FAA 7100.41 Design Team Outcomes and Conceptual Procedures

Presentation to: DC Metroplex BWI Community Roundtable

Date: April 24, 2018

BWI ANTHM RNAV STAR (Arrival)

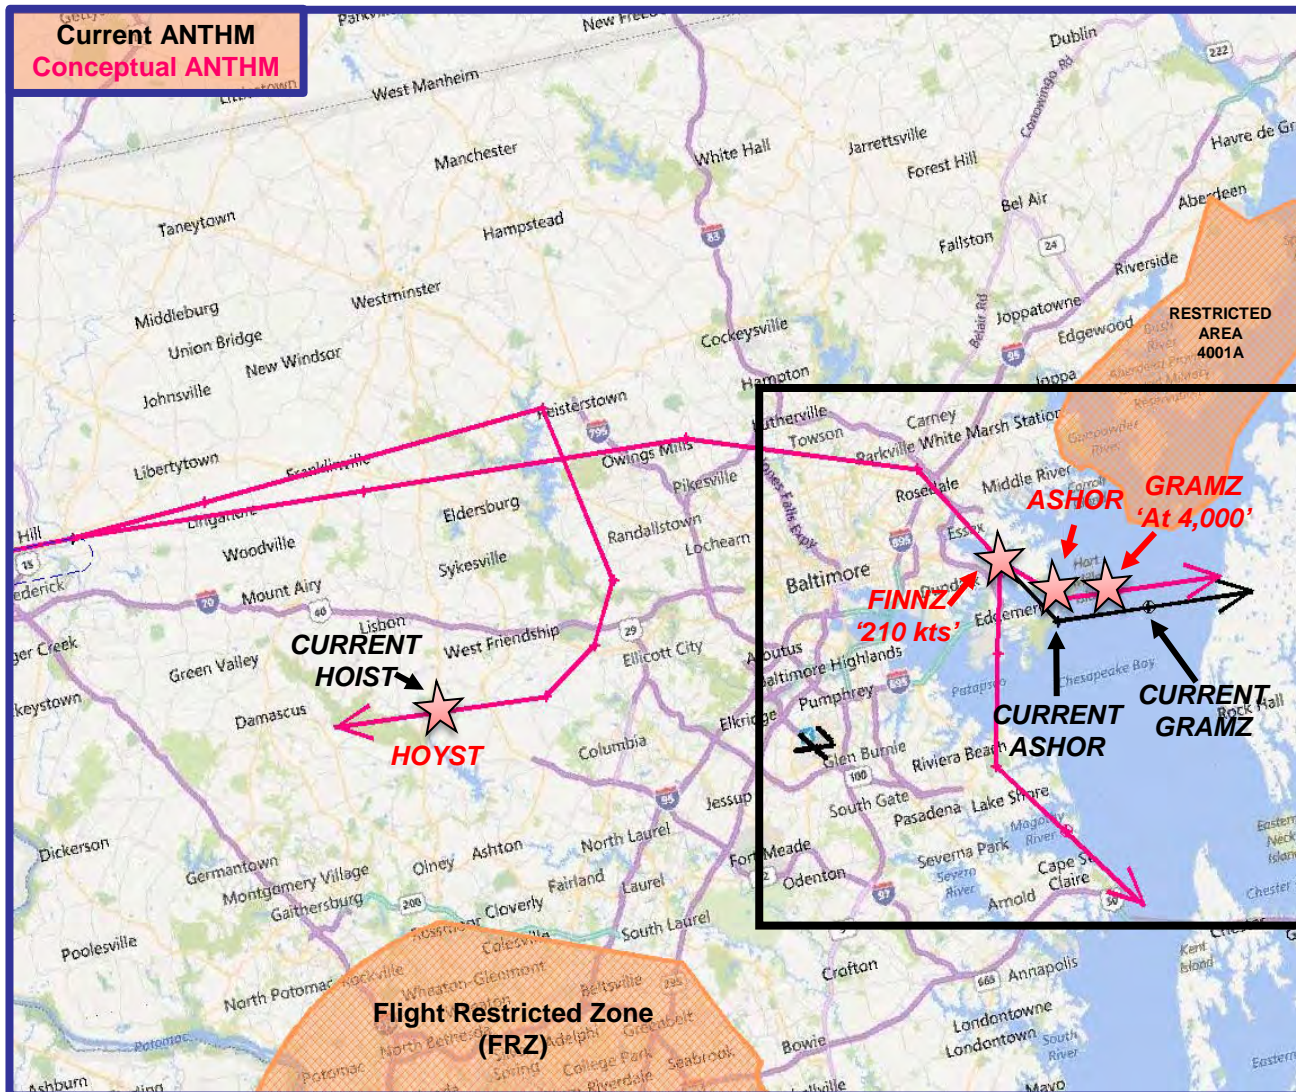
- Serves jet arrivals from the west
- Runway 28 Usage:
 - ✓ 4.8% (6,223 flights/year)
- Spelling change – HOIST to HOYST
- Runway 28 Changes:
 - ✓ Added 210 kts speed restriction at FINNZ for criteria
 - ✓ Moved ASHOR and GRAMZ 0.9 nm north to provide a 4-mile downwind to RWY 28
 - ✓ Moved 4,000 ft altitude restriction from ASHOR to GRAMZ for criteria

BWI TRISH RNAV STAR (Arrival)

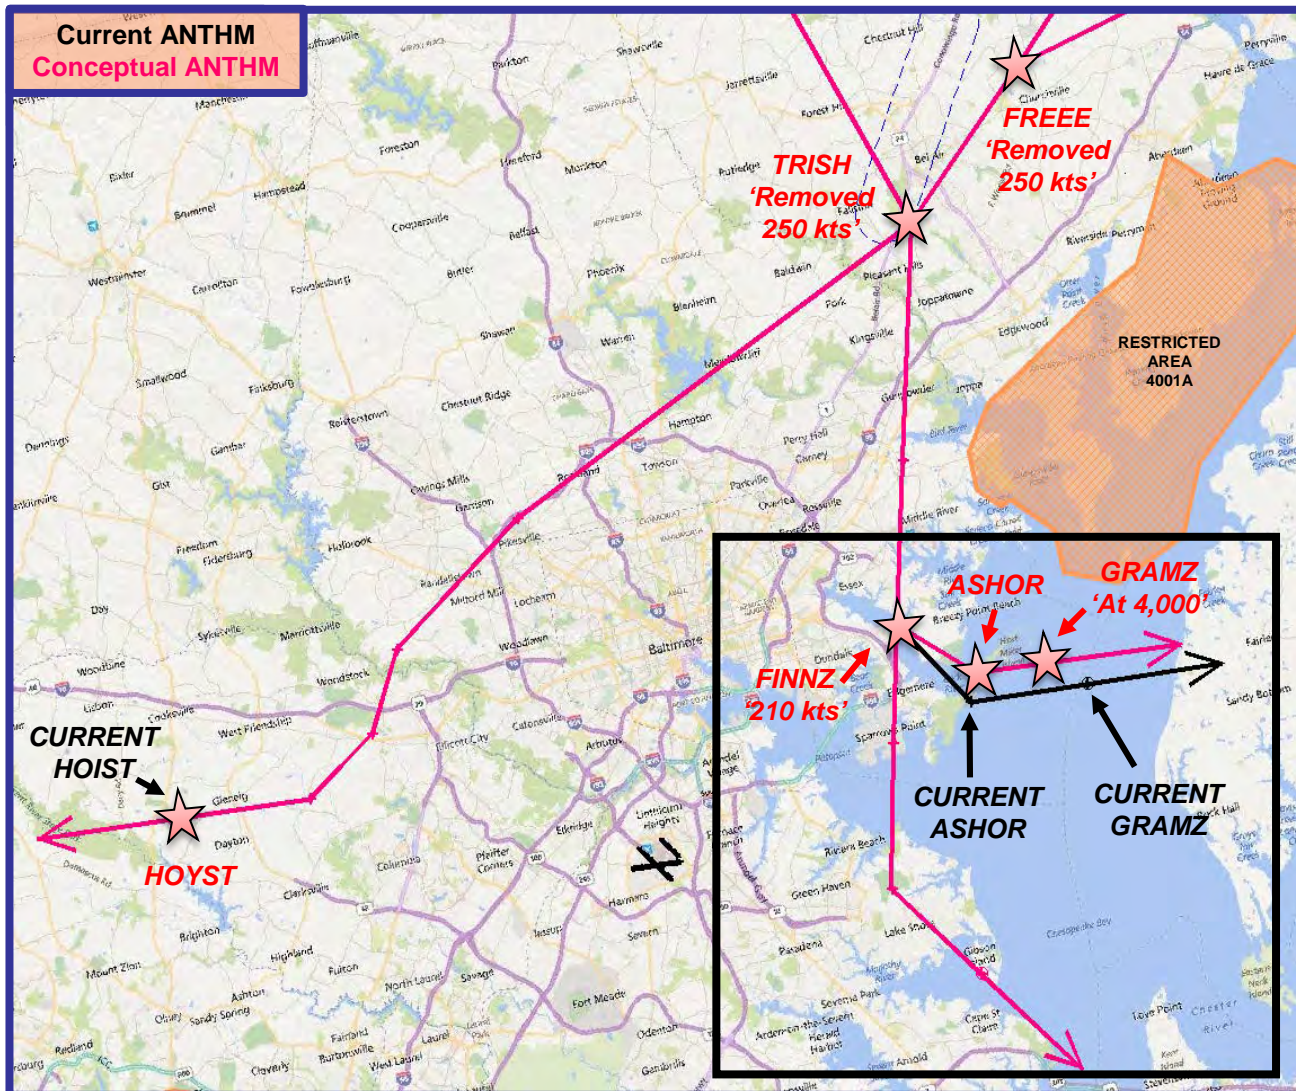
- Serves jet arrivals from north
- Runway 28 Usage:
 - ✓ 4.8% (6,223 flights/year)
- Spelling change – HOIST to HOYST
- Runway 28 Changes:
 - ✓ Added 210 kts speed restriction at FINNZ for criteria
 - ✓ Moved ASHOR and GRAMZ 0.9 nm north to provide a 4-mile downwind to RWY 28
 - ✓ Moved 4,000 ft altitude restriction from ASHOR to GRAMZ for criteria
- Removed 250 kts speed restriction at FREEE and TRISH for criteria

BWI MIIDY RNAV STAR (Arrival)

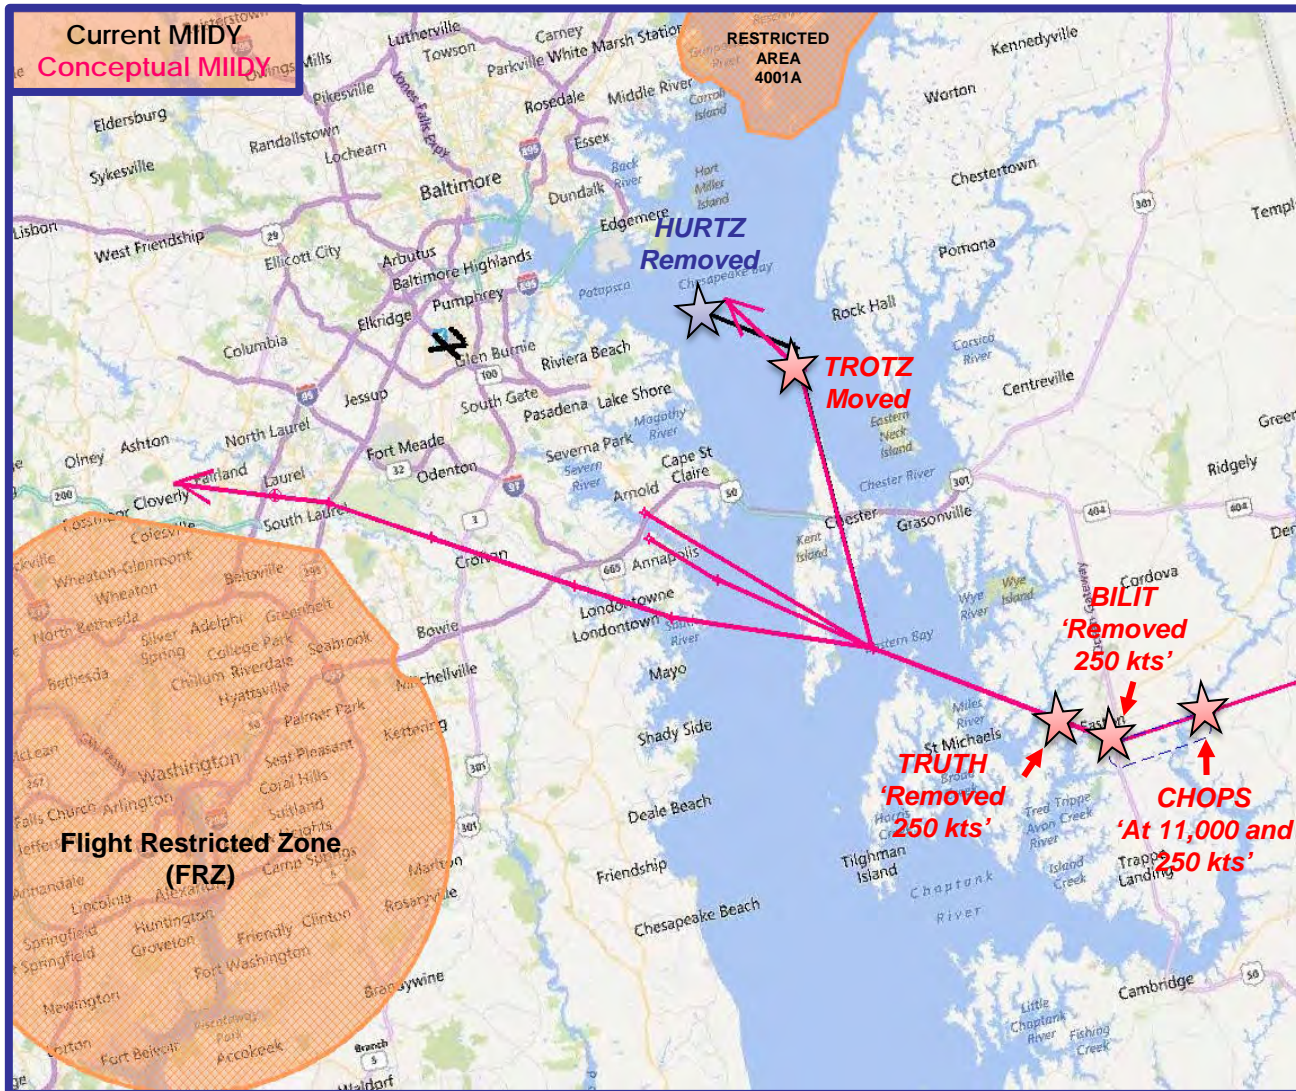
- Serves jet arrivals from the southeast
- Runway 28 Usage:
 - ✓ 4.8% (6,223 flights/year)
- Added 11,000 ft and 250 kts speed restriction at CHOPS to match existing agreements between Washington Air Route Center (ZDC) and Potomac TRACON (PCT)
- Removed 250 kts speed restrictions from BILIT and TRUTH to avoid redundancy
- Runway 28 Changes:
 - ✓ Removed HURTZ
 - ✓ Moved TROTZ 1 nm southeast to help with RWY28 sequencing
